## DISPOSITION OF PUBLIC COMMENTS

AC 25-17A, Change 1, *Transport Airplane Cabin Interiors Crashworthiness Handbook*

Prepared by [John Sheldon](#), ANM-115

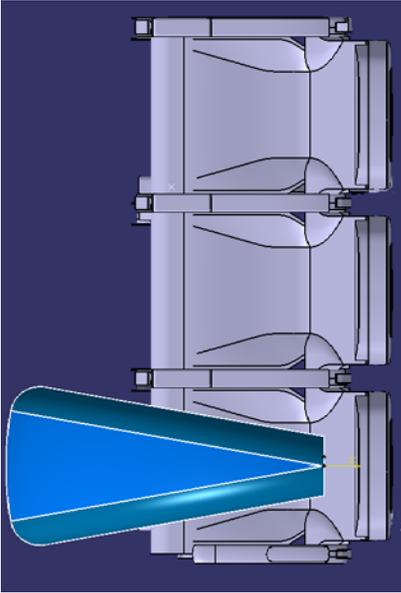
No.	Comment	Requested Change	Disposition
	<b>Commenter: Ad HOC SAE Industry comments</b>		
		<ul style="list-style-type: none"> <li>• air to ground (hard landings)</li> <li>• air to ground (other types of impacts).</li> </ul> <p>As this research was from 1982, more recent survivable emergency landings were reviewed, dating back to 1999. Industry's determination is that the findings in the FAA report are still valid, with the airplane either experiencing a runway overrun or landing short of the runway being the most common survivable emergency landing scenarios (70%).</p> <ul style="list-style-type: none"> <li>• Runway overrun = 23 occurrences</li> <li>• Landing short of runway = 6 occurrences</li> <li>• Veering off runway = 5 occurrences</li> <li>• Other (Approach, etc.) = 7 occurrences</li> </ul> <p>Due to the prevalence of the aircraft aligned with the runway before the emergency landing, Industry concurs with the FAA that the aircraft yaw angle at impact is typically less than 10 degrees relative to the airplane longitudinal axis for serious but survivable accidents.</p> <p>To accommodate previous FAA comments regarding the width of the headstrike zone in relation to seat backs, Industry agrees that the entire width of the seat back should be considered when evaluating potential head strike surfaces.</p> <p><u>Proposal:</u> The width of the head strike zone is</p>

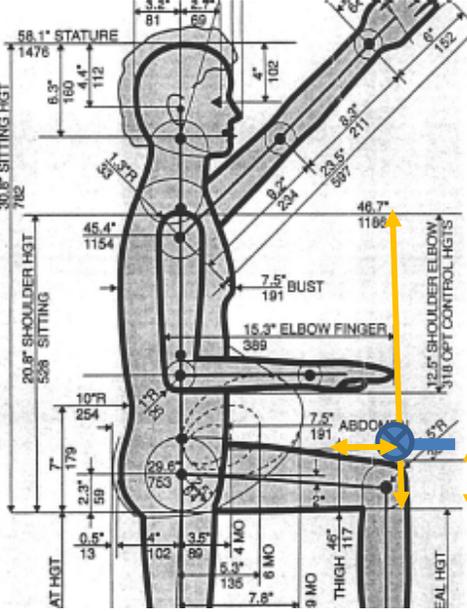
No.	Comment	Requested Change	Disposition
<b>Commenter: Ad HOC SAE Industry comments</b>			
7.	Recommend paragraph b(5) in Sections 81 through 88 be changed as follows:	<p><u>Proposal:</u> Instead of using the seat cushion edge to limit the headstrike zone (see Position #1), Industry proposes using the sitting 5% female as the basis for this limit, as the 5% female is typically the smallest occupant size used in evaluating injury potential for §25.785. Two vertical measurements were chosen to calculate this limit: shoulder height, and thigh height. The shoulder height is chosen as it is slightly below the head, therefore surfaces closer than this distance would not be contacted by the head. The thigh height is subtracted as the occupant typically pivots about a point near the top of the thigh and not at the ischial tuberosities.</p> <p>5% female anthropometric measurements:</p> <p>Shoulder (21.14 inches) – thigh (5 inches) + buttock to mid-torso (4.73) = 20.87 inches ≈ 20.5 inches</p> <p>Reference: “The Measure of Man &amp; Woman”, Henry Dreyfuss Associates, 2002</p>	<p>We agree with changing the limit from the forward edge of the seat cushion to a fixed dimension of 20.5 inches. For simplicity, we will call this the shoulder height of the seated 5% female. We do not agree that the head strike plane should start at a plane 20.5 inches forward of the CRP and have left this portion of the head strike arc unchanged. We have made the following change:</p> <p>“The striking radius of the head (head strike zone) is considered to be a zone whose length is bounded between an arc at the shoulder height of the 5<sup>th</sup> percentile female occupant (20.5-inches) and an arc at the limit of the head path (35-inches) whose centers are at the intersection of the plane of the uncompressed top of the seat cushion with the plane of the uncompressed front of the back cushion; commonly referred to as the cushion reference point (CRP), as shown in figure 8X-2.”</p>

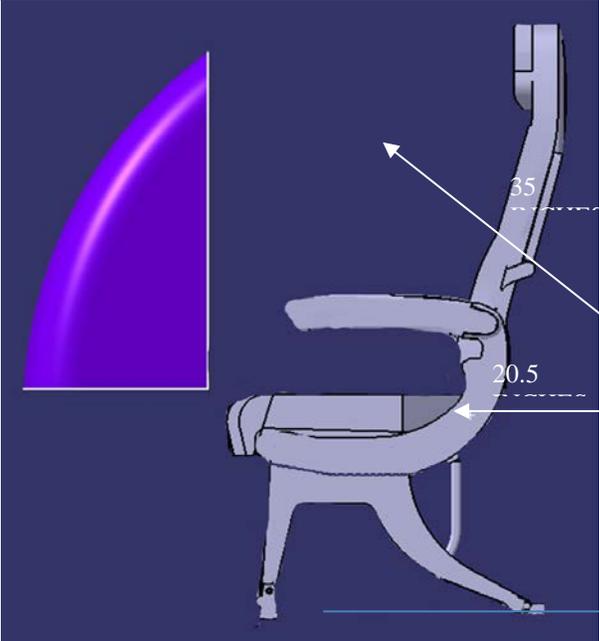
No.	Comment	Requested Change	Disposition
<b>Committer: Ad HOC SAE Industry comments</b>			
		 <p>Therefore, items less than 20.5 inches forward of the CRP are not considered likely to cause serious injury to the occupant’s head. A figure of the modified headstrike zone is shown below.</p>

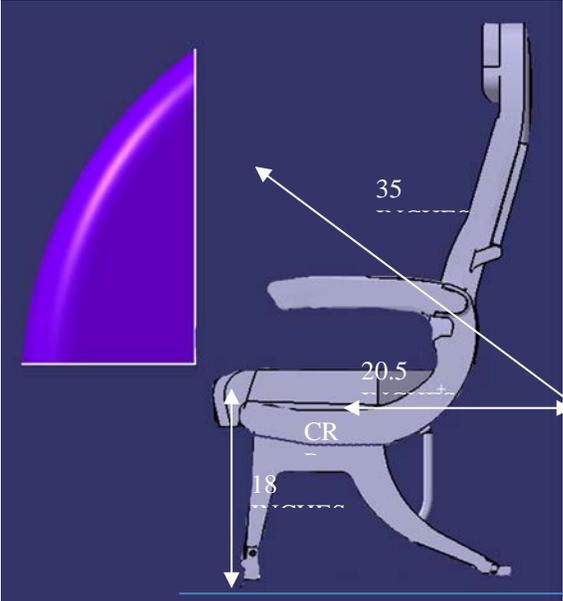
No.	Comment	Requested Change	Disposition
	<b>Commenter: Ad HOC SAE Industry comments</b>		
		<p>guidance.</p> <p><u>Proposal:</u> Compliance to §25.785(k) is sufficient to evaluate surfaces outside the headstrike zone.</p> <p>Based upon the four Industry positions described, recommended wording changes to paragraph (b)(5) is as follows.</p> <p>The striking radius of the head (<b>head strike zone</b>) is considered to be <b>a zone whose length is bounded by the following:</b></p> <p>A 35 inch arc radius with the arc center located at the seat Cushion Reference Point (CRP), with the arc length spanning a distance from vertical to a height of 18 inches from the floor (see Figure 8#-2). The CRP is <del>n arc at the forward edge of the seat bottom cushion and an arc at the limit of the head path (35 inches) whose centers are</del> at the intersection of the plane of the uncompressed top of the seat cushion with the plane of the uncompressed front of the back cushion; commonly referred to as the cushion reference point (CRP), <del>as shown in figure 82-2.</del> Previously this was referred to as seat reference point (SRP). However, with the advent of dynamic seat testing the definition for SRP was changed (refer to current version of AS8049). The CRP is located midpoint between lap belt anchor points. <b>The head strike zone extends in the direction parallel to the airplane longitudinal axis. The width of the head</b></p>

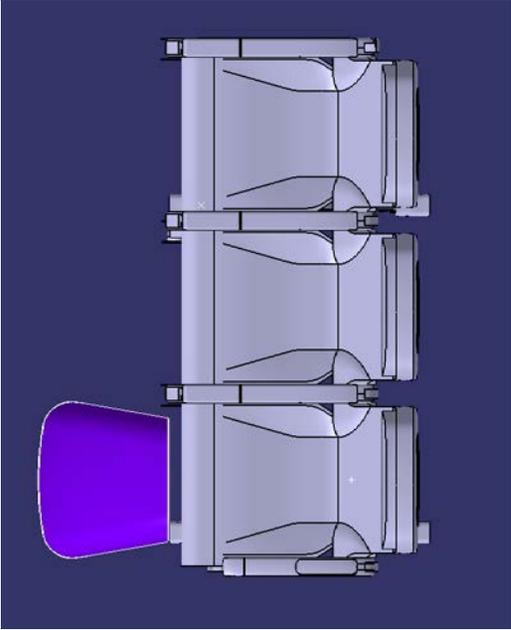
No.	Comment	Requested Change	Disposition
<b>Commenter: Ad HOC SAE Industry comments</b>			
		<p><del>strike zone is bounded by a vertical plane through the intersection of the centerlines of each armrest and the CRP as shown in figure 82-2.</del></p> <p>A 95<sup>th</sup> percentile male headform moved along a 35 inch line segment yawed <math>\pm 10</math> degrees from the airplane longitudinal axis as shown in figure 8#-2. The 95<sup>th</sup> percentile male headform for this analysis is a circle with a diameter of 6.5 inches (16.5 cm). A vertical plane 20.5 inches forward of the CRP.</p>
